NUCLEAR FUEL SERVICES, INC.

Subject: Response to the Request for Additional Information Concerning License Renewal for SNM-124

**NFS RESPONSE TO RAI
CONCERNING LICENSE RENEWAL FOR SNM-124**

Figure 2-1

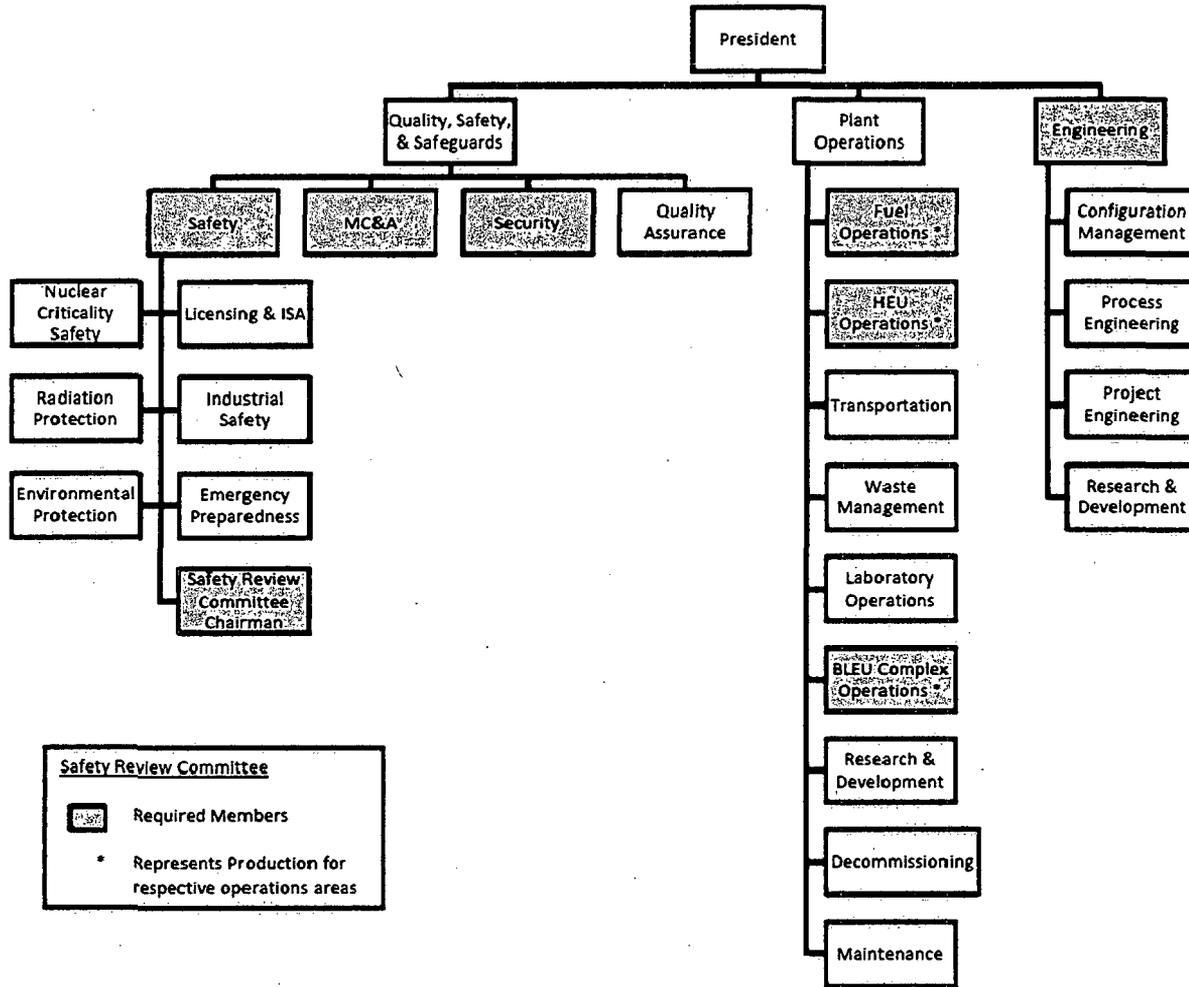
Section 2.2 of the application states that Figure 2-1 shows the current NFS functional organization. However, Figure 2-1 differs from organizational charts and resumes provided during recent management meetings. For example, in recent management meetings, information was provided about a chief nuclear safety officer who reports to the President. Figure 2-1 of the application fails to identify this position. The resume for the chief nuclear safety officer states that the officer oversees licensing activities, critical safety investigations, safety and regulatory initiatives, and planning activities. In addition, the chief nuclear safety officer serves as an alternate to the Director of Safety and Regulatory. The responsibilities and authorities of the chief nuclear safety officer appear to conflict with those of other managers described in the application.

Figure 2-1 has been updated to reflect recent organizational changes and is included on page 12. Minor changes also need to be made to sections 2.2 and 2.3 for consistency with Figure 2-1. As stated in the cover letter, these will be submitted at a later date. The chief nuclear safety officer position has been eliminated; therefore, the questions concerning this position are no longer applicable. All functional areas shown in Figure 2-1 have responsibility for health, safety, and environmental protection.
